Chorka Textile Ltd (Extension -2)

15th October 2019

Observations

Bracing missing at Southeast Corner

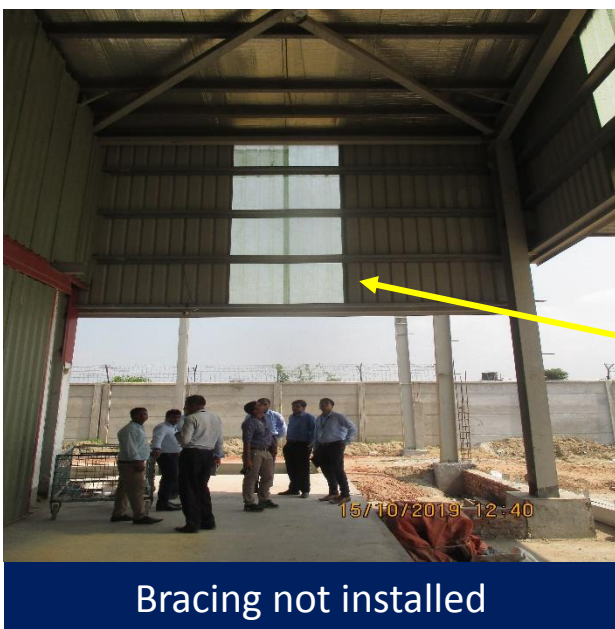
Bracing not installed

Bracing not installed

Vertical bracings are not installed as per drawings on grid 1-2 and H-I. Factory engineer is required to install missing bracings otherwise provide alternative load transferring media from design review.

Significant gaps in connection

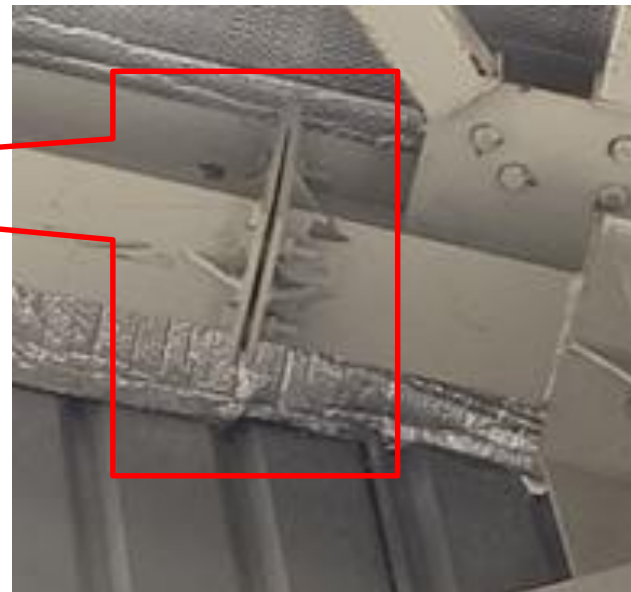
Gap in column-rafter joint

Significant gaps were found in column-rafter-rafter joint. Factory engineer is required to carry out suitable remedial works.

Gap in rafter-rafter joint
